# CI 136.8.11 Link Training Issue (comment #1) Update

November 2020

# Summary

Figure 136-7—PMD control state diagram

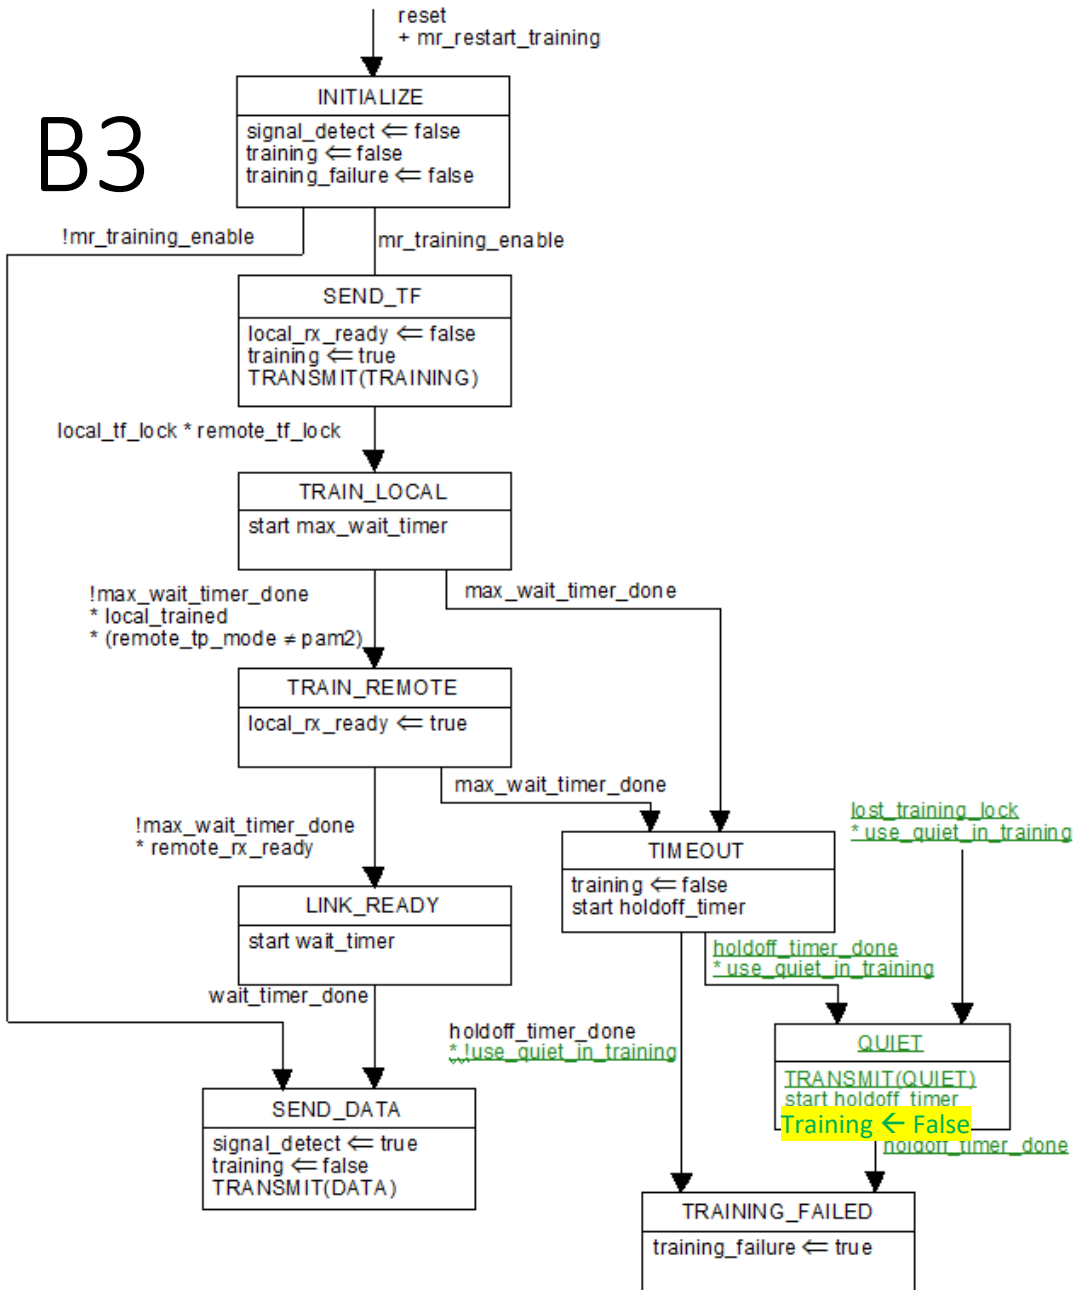
- Both use tx-based squelch mechanism to induce/detect an abort.
  - B3 at the end of the state machine
  - B4 at the beginning and end of the state machine
- Remote end monitors for tx squelch and aborts training process when necessary

B3

Figure 136-7 – PMD control state diagram

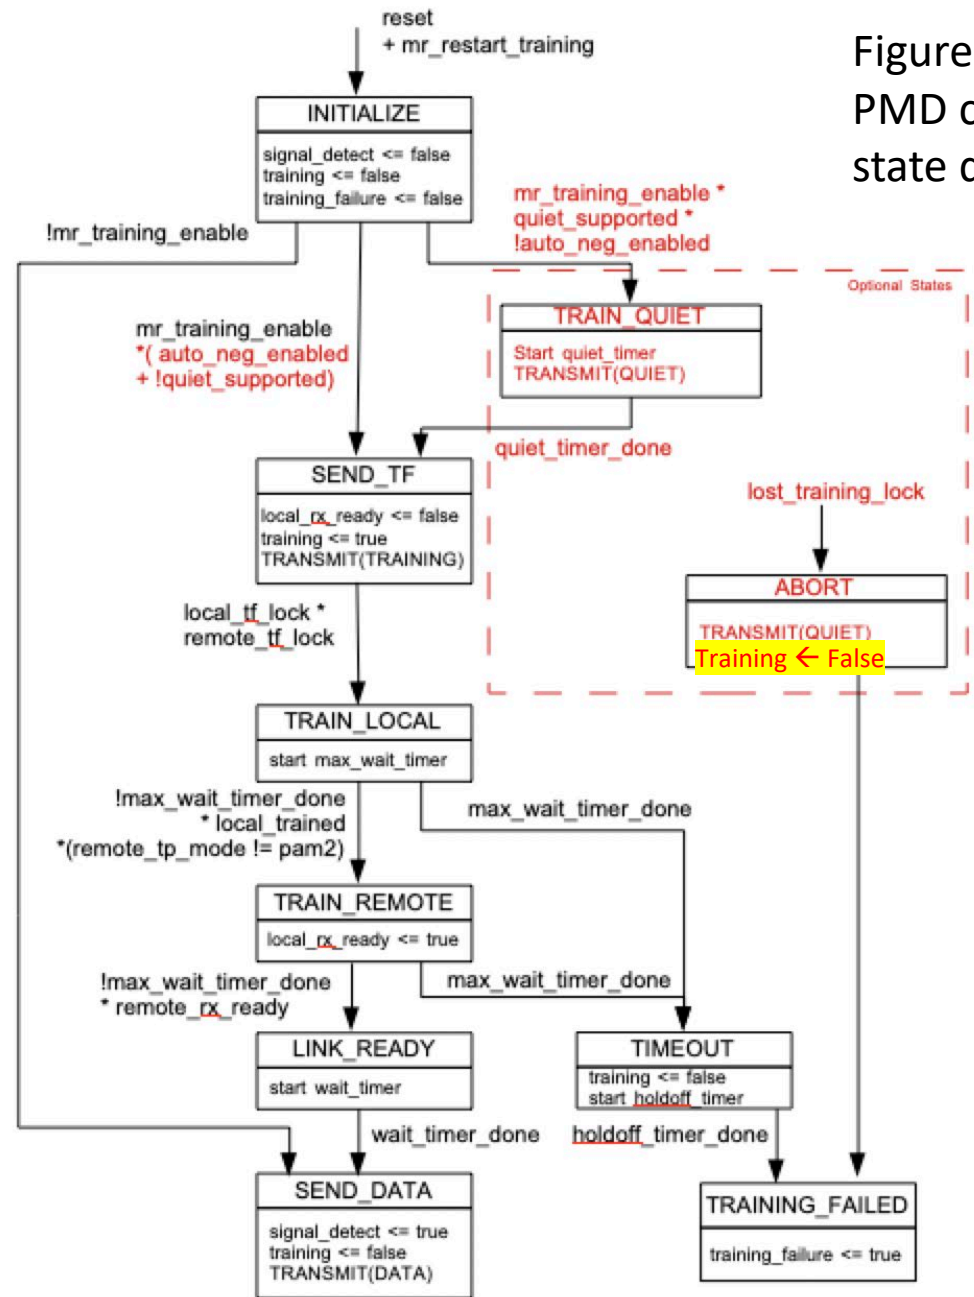
B4

TRANSMIT(tx\_mode)

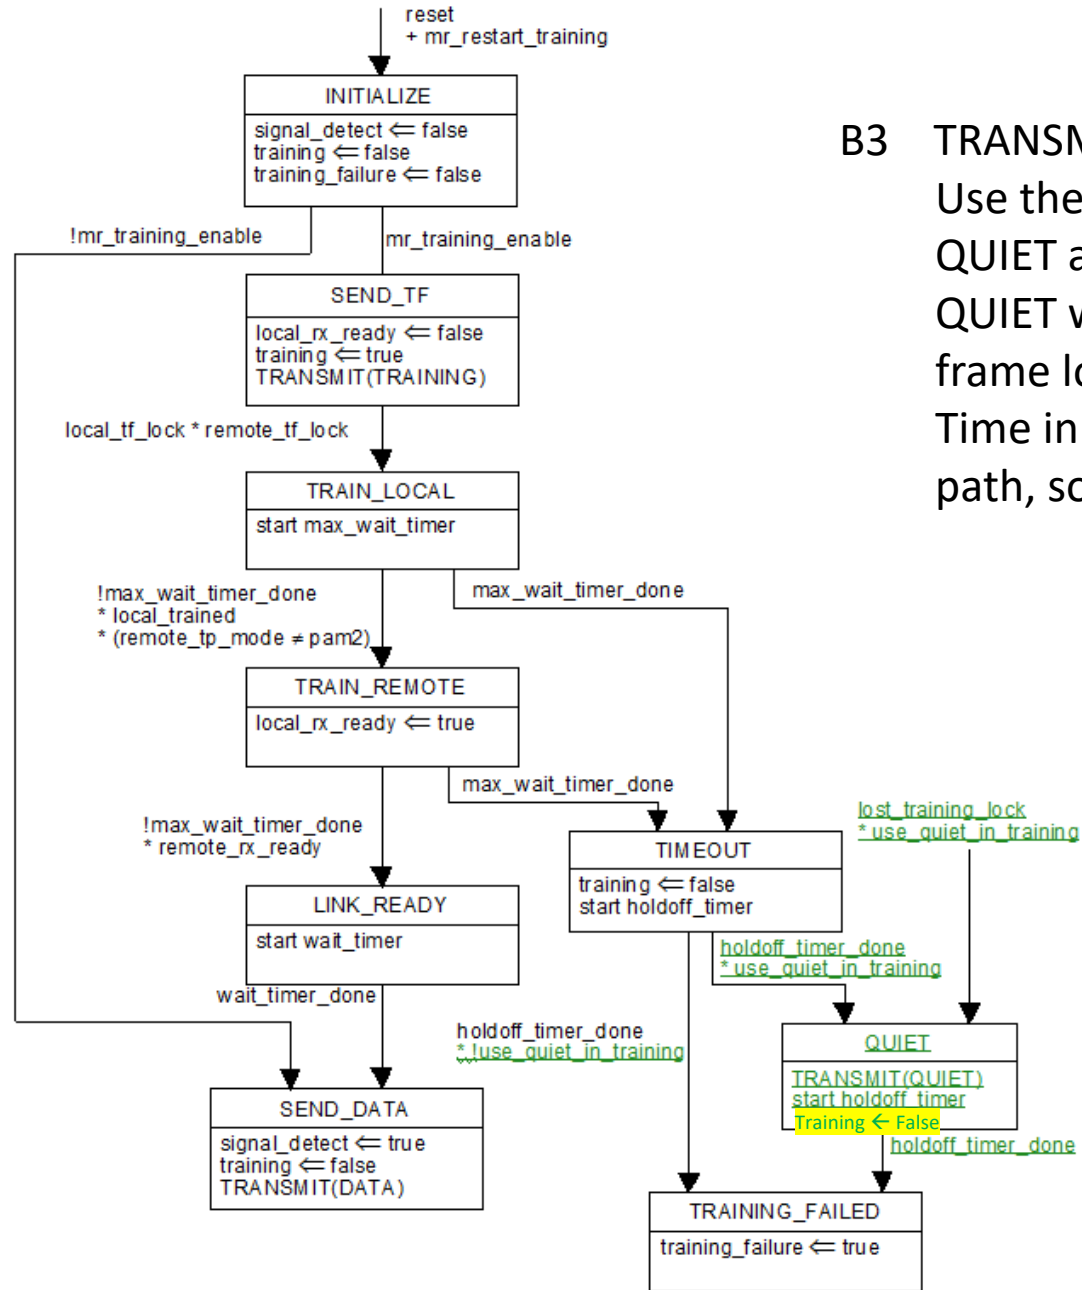
- Functions in Cl 136

Controls the output of the PMD transmit function on the current lane. When tx\_mode=DATA, the PMD transmit function output is the parameter of the PMD:IS\_UNITDATA\_i.request primitive (see 136.3). When tx\_mode=TRAINING, the PMD transmit function output is the stream of symbols generated by the PMD control function. When tx\_mode=QUIET, the PMD transmitter is turned off, equivalent to setting PMD\_transmit\_disable\_i to one (see 136.8.7).

- *<modify the first paragraph as follows>*
- The PMD transmit function has three operating modes DATA, TRAINING and QUIET. The operating mode is controlled by the PMD control state diagram (Figure 136–7).
- *<add the following paragraph to the end of 138.8.2>*
- When operating in QUIET mode the PMD transmit function shall turn off the transmitter such that the transmitter drives a constant level (i.e., no transitions) and does not exceed the differential peak-to-peak output voltage (max.) with Tx disabled in Table 136–11.

Figure 136-7 – PMD control state diagram

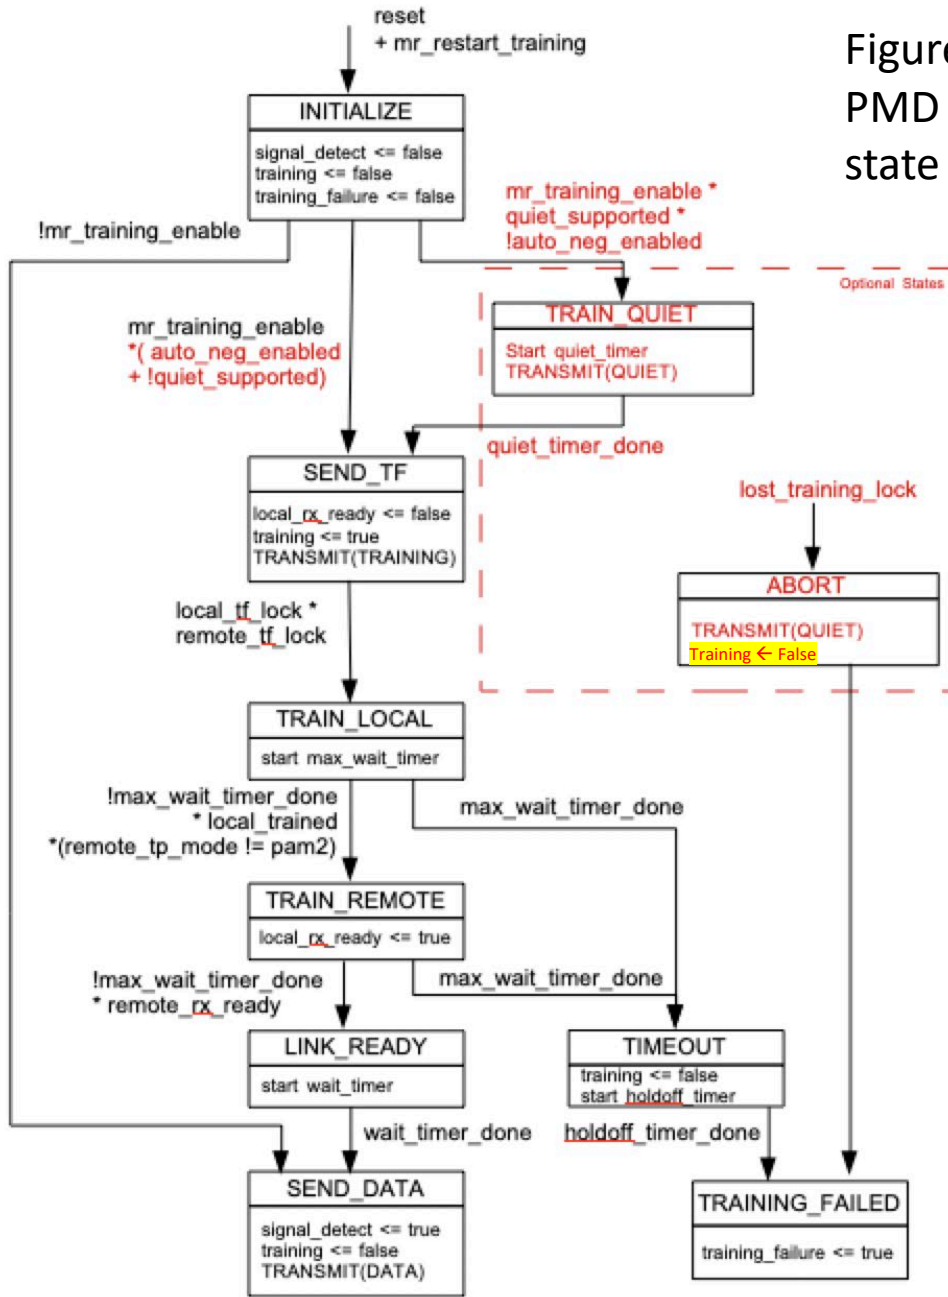
B4

- `auto_neg_enabled` – Boolean variable equal to `mr_autoneg_enable` when auto-negotiation is supported (see Cl73) otherwise set to `FALSE`.
- `quiet_supported` – Boolean variable set to `TRUE` if the optional `QUIET` state is supported, otherwise set to `FALSE`.
- `lost_training_lock` – Boolean variable that is set to `TRUE` when the PMD control function is in `TRAIN_LOCAL` or `TRAIN_REMOTE` states (see Figure 136-7) and `local_tf_lock` is `FALSE` continuously for a period 20ms or the detection of a non-compliant input signal has occurred continuously for 1ms. When `quiet_supported` is `FALSE`, this variable is always `FALSE`.

- `quiet_timer`– This timer is started when the PMD control state diagram enters the `TRAIN_QUIET` state. The terminal count of `quiet_timer` is 80ms +/- 2%.

Figure 136-7—PMD control state diagram

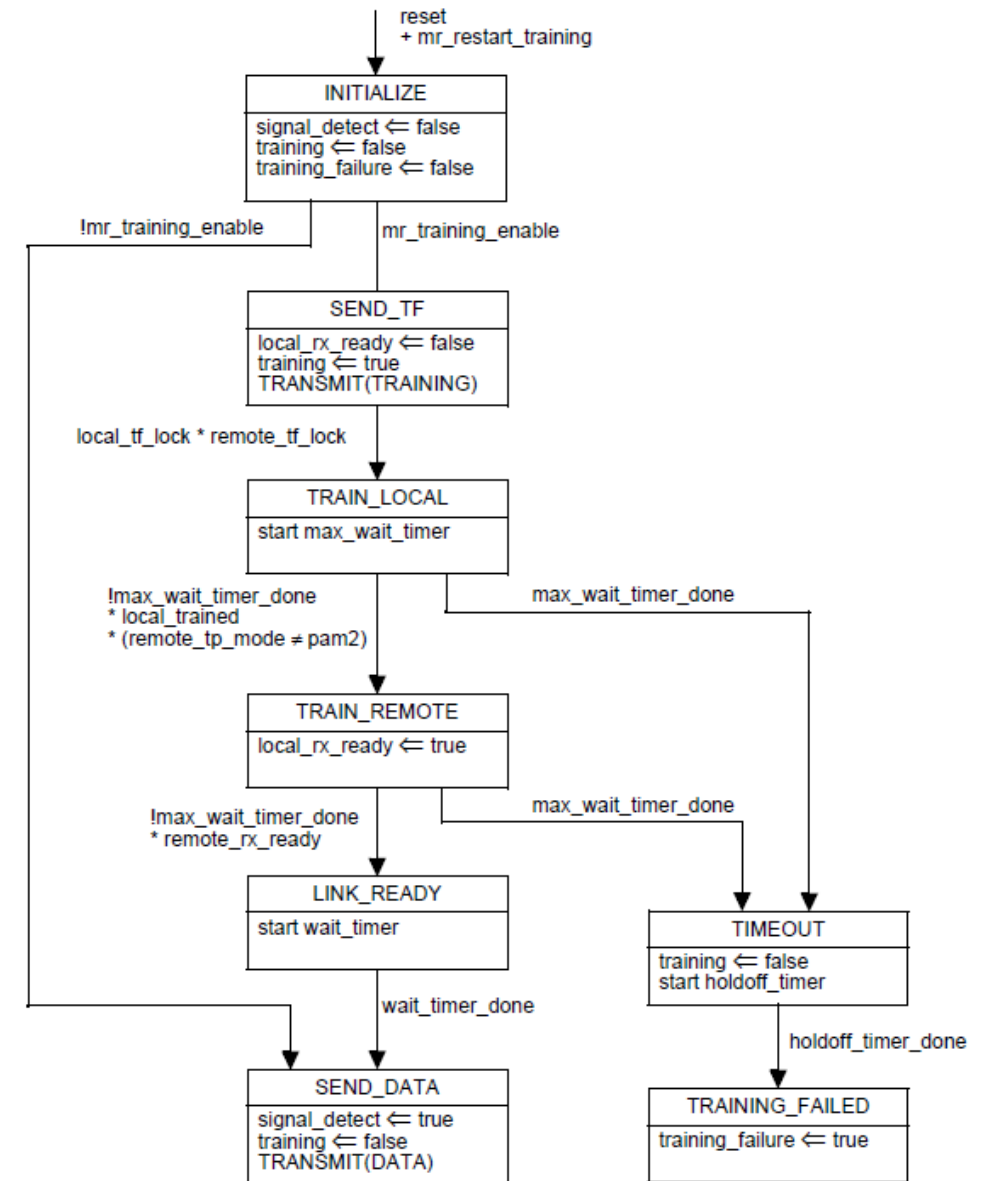
- Add monitoring of the local and received frame lock status (with TBD hysteresis) after the initial frame lock is achieved
- Implement an abort signaling mechanism

- The currently defined state machine in Clause 136.8.11 (Figure 136-7) does not autonomously recover from a partner restarting during link training in this “force PHY speed” case
  - Note: observed when the Clause 73 Auto-Negotiation state machine is not used.
- Unless a high-level management agent (i.e. SW or FW) detects the condition, the result could be either a persistent link down (i.e. link never comes up) or a link oscillation (up/down/up/down/etc).
